CAMINO REAL REGIONAL MOBILITY AUTHORITY BOARD RESOLUTION

CONSTRUCTION CONTRACT CHANGE ORDER NUMBER

6

5. New or revised plan sheet(s) are attached and numbered: L 10 of L 14 Irrigation Plan

SHEET L10 OF L14

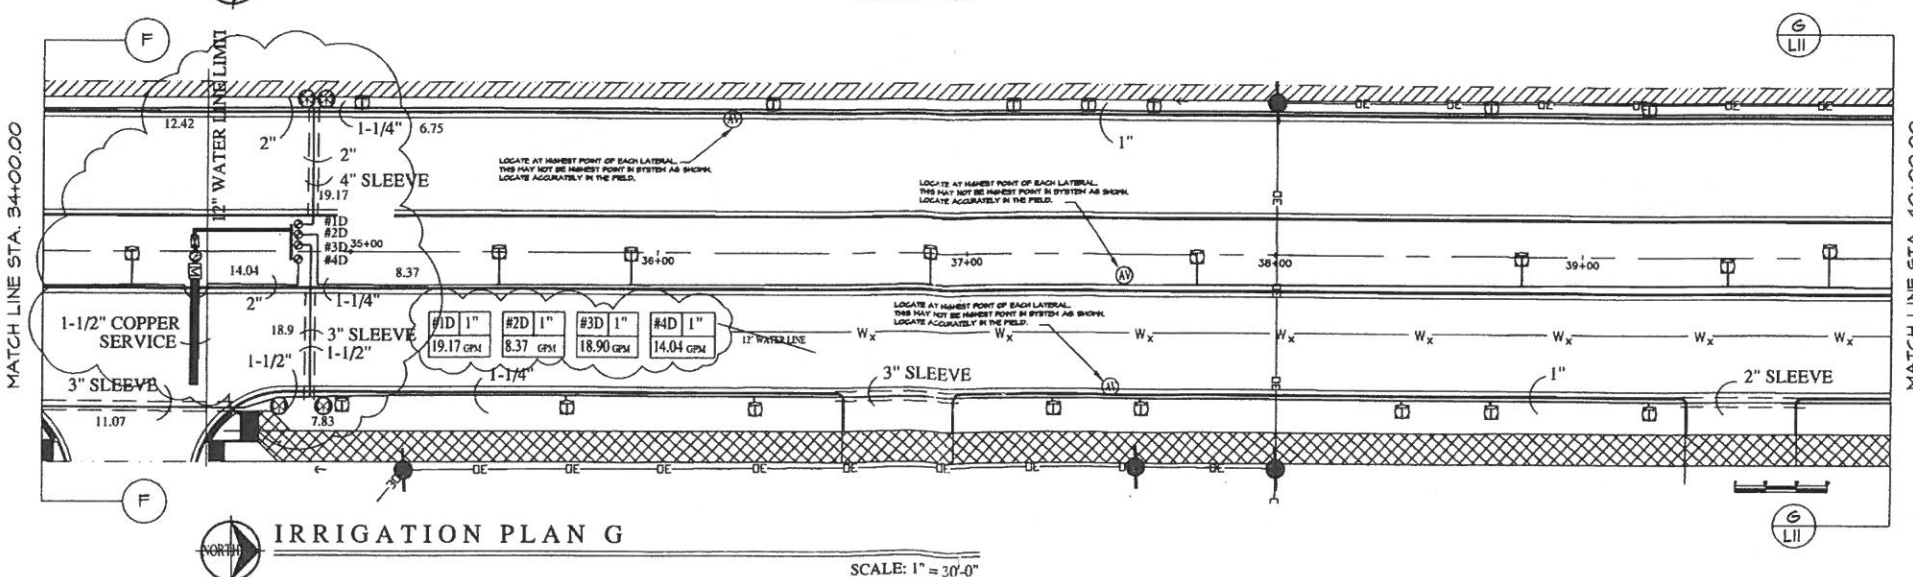
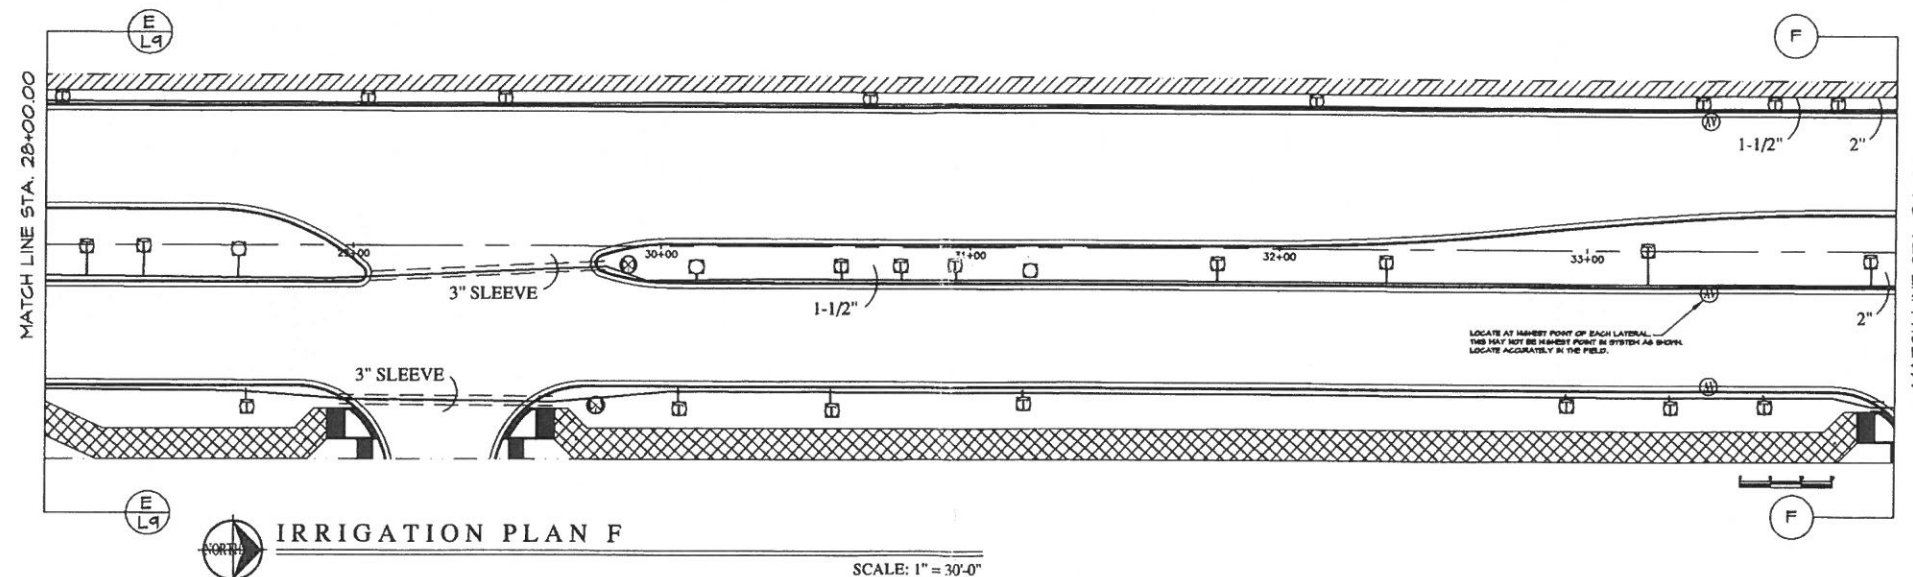
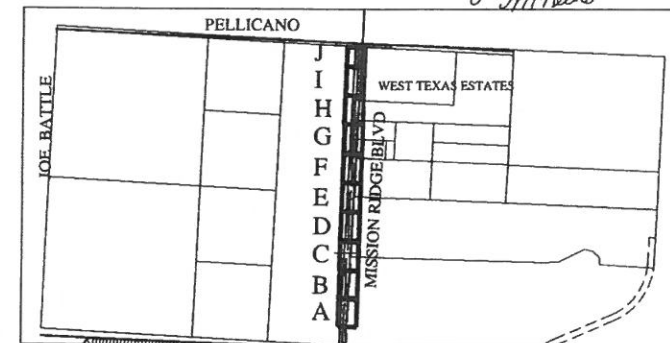
This change order is to pay the contractor for adding a new sleeve at the new water meter location station 34+50 due to the existing waterline was not at the planned location Station 35+25. This Change Order will not affect pedestrian elements. No time is added by this CO.

Per our meeting on Tuesday, I have the additional cost to place new sleeves where the pipe that has already been installed. This additional cost includes labor and material, to have the new sleeves installed at new proposed meter location (34+50). Please feel free to contact me with any questions.
